**Subject: Comment and objection for Planning Application 13 Chalcot Gardens:  
(2024/4823/P)**

**Objection to 13 Chalcot Gardens: (2024/4823/P) Proposed replacement Outbuilding (Garden Studio) within the rear garden.**

Figure 1. Garden Studio Proposal and scale as shown in application. (Ref pg. 11)

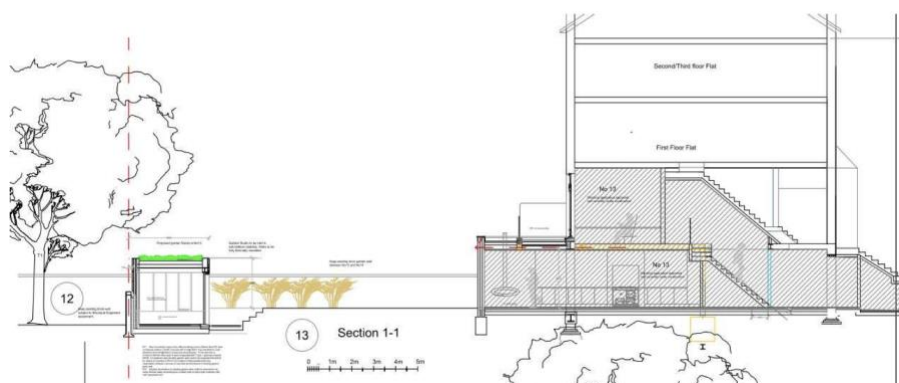
The Garden Studio is set 10m from the main residences and facing the residences and as outlined in Policy A1 Section 2.4 this condition is not met. Further to this the nature of the low boundary walls, which is in the character of the Conservation Area and Gardens, will mean inevitable overlook. Please see Figure 1 below for reference of distances as per application.

Figure 2. Overlook of garden building and proportionality to surroundings in vicinity.

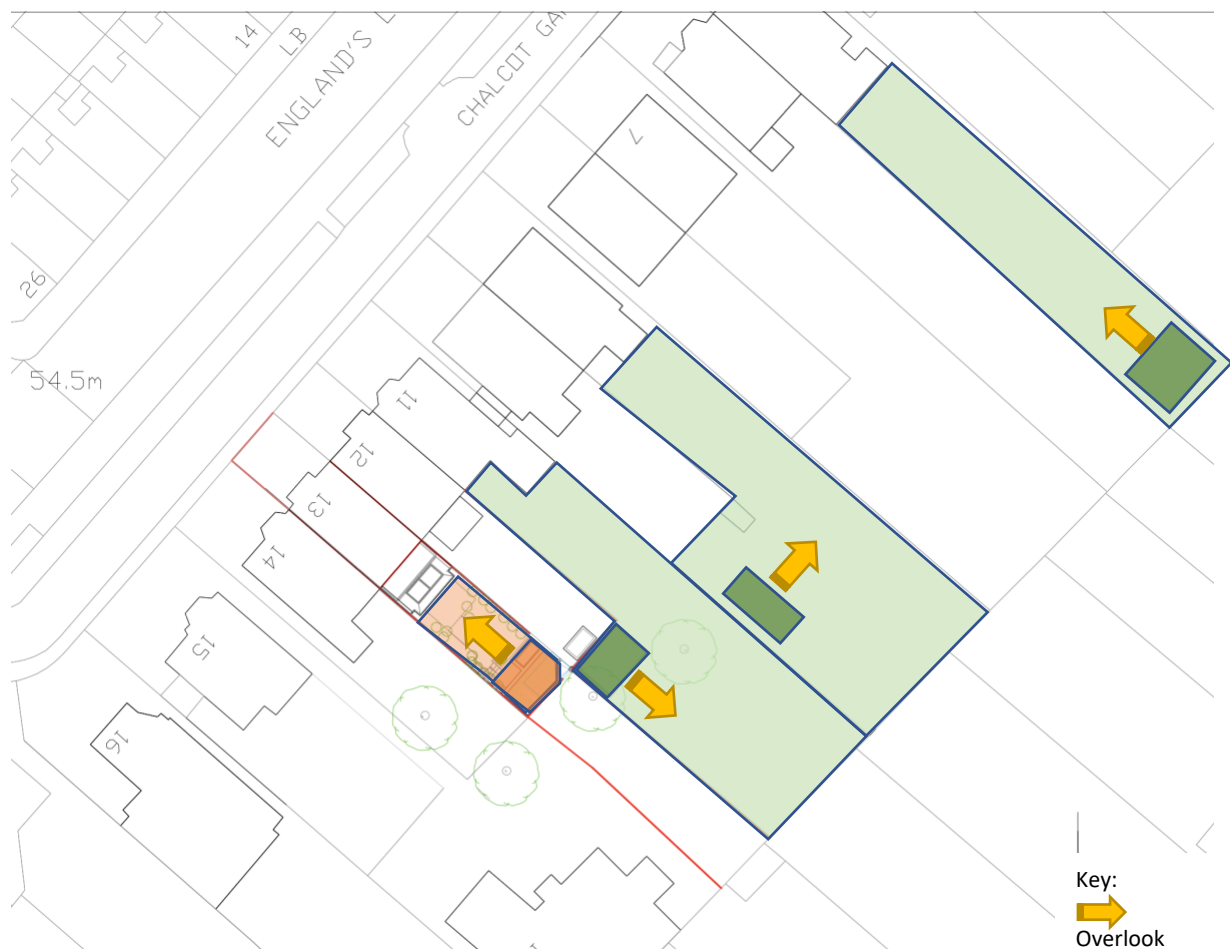
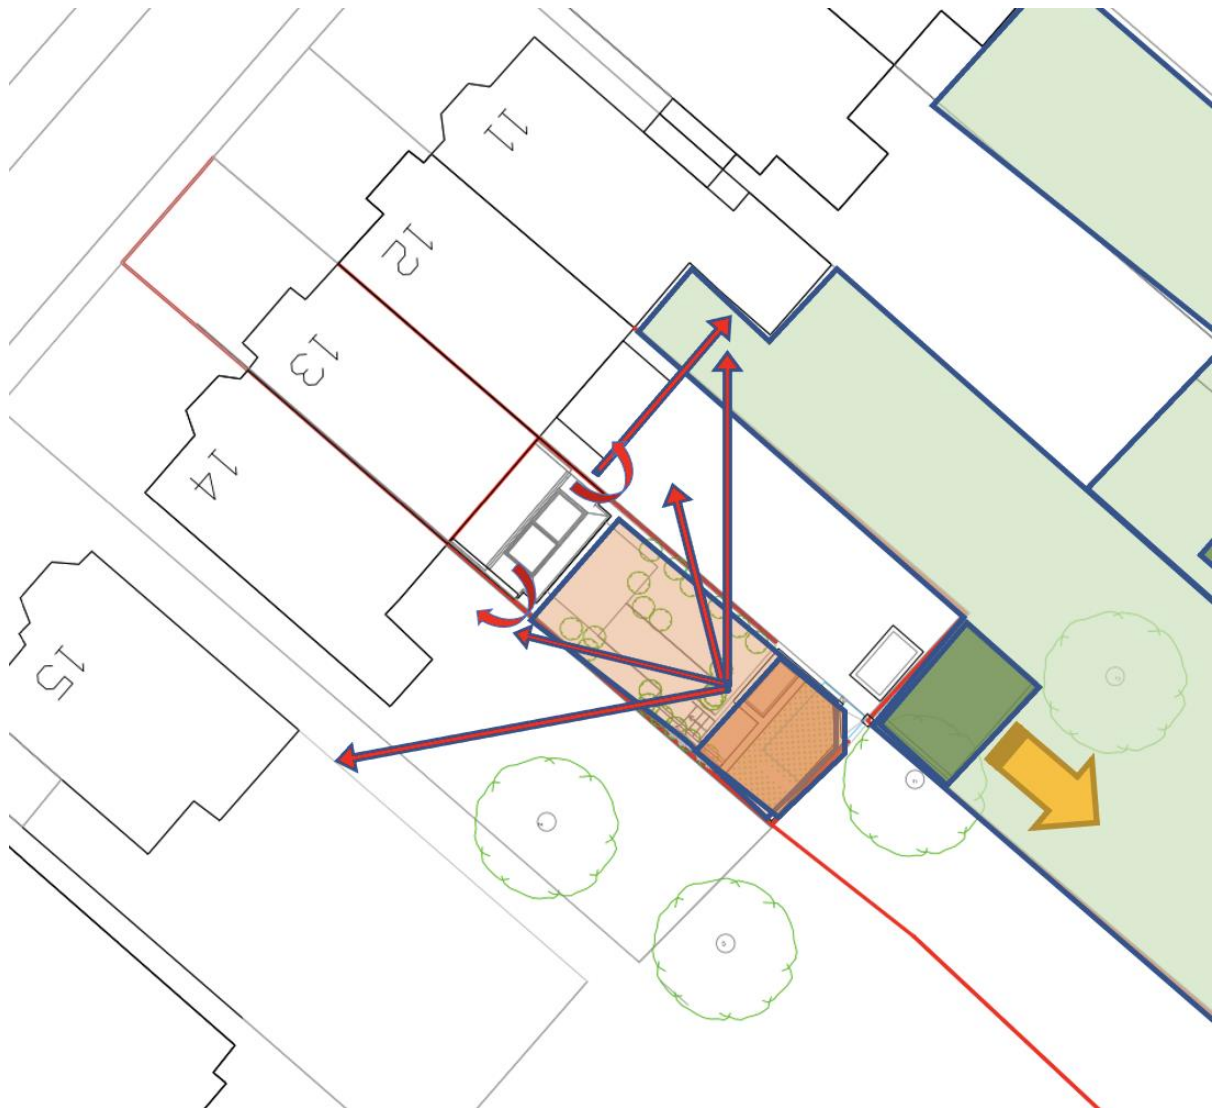
As shown in Figure 2 it should be noted that Outbuildings windows/sliding glass doors in No. 9 and No.11 do not overlook or face the buildings and windows of the neighbouring residences allowing for their preservation of privacy.

The outbuilding in No.5 is set significantly further back, approximately 40m away and surrounded by large trees which along with the depth provide significant amounts of privacy to neighbouring residences.

In the case of all the outbuildings referenced as a precedent, they are all set considerably further back in the gardens than the proposed development.

In relation to size and proportionality please refer to Figure 2. As can be seen all the “similar” garden buildings used to set a precedent sit in significantly larger gardens. They all benefit from gardens that are multiple times larger than 13 Chalcot Gardens. Their outbuildings’ relative size

(smaller than the proposed Garden Studio) to their gardens, direction of outlooks and significantly greater soft landscaping & large trees makes them a poor comparative reference point for the acceptability of this proposal. The proposed garden Studio at 13 Chalcot Gardens would use 25% of the available garden relative to less than 10% of the gardens in No. 5, No. 9, and No. 11.

Figure 5. A large portion of the boundary wall is raised.

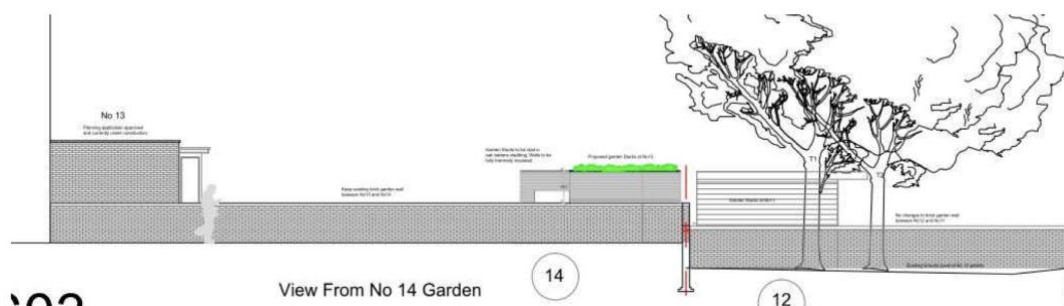
Further to the erosion of the garden space the erection of high walls on either side take away from the character of the conservation area defined by low boundary walls which allow for a sense of openness and the free movement of local wildlife (see Figure 5). The Garden Studio proposal is also wall to wall and effectively hermetically seals the Garden in no. 13 from the other gardens impacting the nature of the conservation area and the movement of wildlife (see Figure 6). The above statement is echoed in the Official Planning Guidance on Design : Paragraph 4.41 of which the sections states:

Figure 6. Wall to wall extensions seal off the garden from other and raise boundary walls.

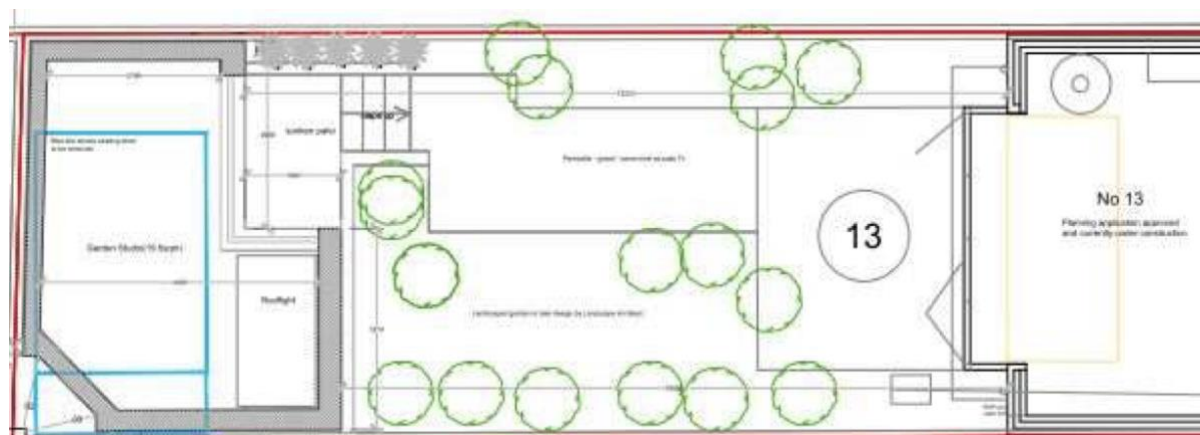
As noted in Figure 6 the Garden Studio proposes to build walls end to end hermetically sealing off No 13 between the 4m extension and the Garden Studio. This will stop the natural movement of wildlife and create a dead zone of concrete, glass and light.
